Lincoln Pond Campground & Luzerne Campground Intensive Use Areas

2025 Proposed Final Unit Management Plans

Lincoln Pond Campground Rustic Playground

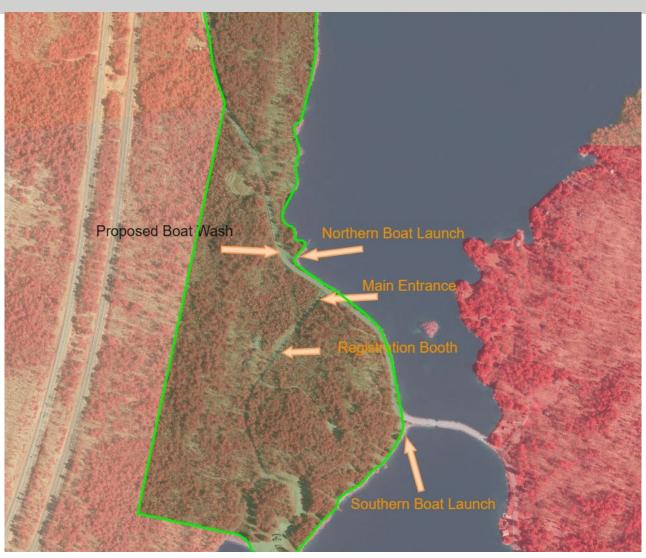
• Public Comment- a playground, described in the UMP, is not identified in the APSLMP as a conforming structure in Intensive Use Areas (IUAs) and the draft UMP does not comply with the APSLMP's Guidelines for Management and Use of Intensive Use Areas. The commenter calls for the playground's removal.

- Rustic playgrounds are approved and described in the 1990 Final Generic Unit Management Plan and Environmental Impact Statement for Campgrounds and Day-Use Areas Volume I.
- The playground structure consists mainly of natural materials to the greatest extent possible, uses natural colors, and blends with the relatively wild and undeveloped character of the Adirondack Park
- Development of the rustic playground met the APSLMP's construction criteria.
- The playground exceeds minimum setback and screening requirements from Lincoln Pond.

Lincoln Pond Campground Boat Launch Locations

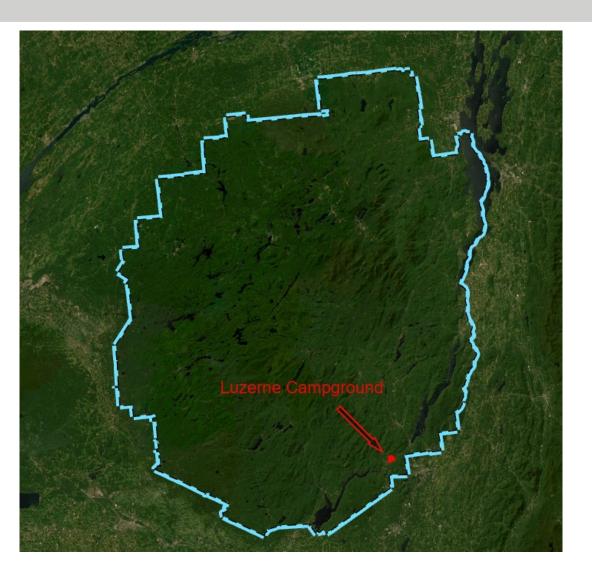
- Public Comment- the southern boat launch should be converted to a fishing and waterway access site.
- APA Response-
 - The APSLMP offers guidelines for the management of intensive use area boat launching sites.
 - For Lincoln Pond Public Campground, the federal Visitor Use Management Framework is being utilized to conduct the APSLMP mandated periodic review.
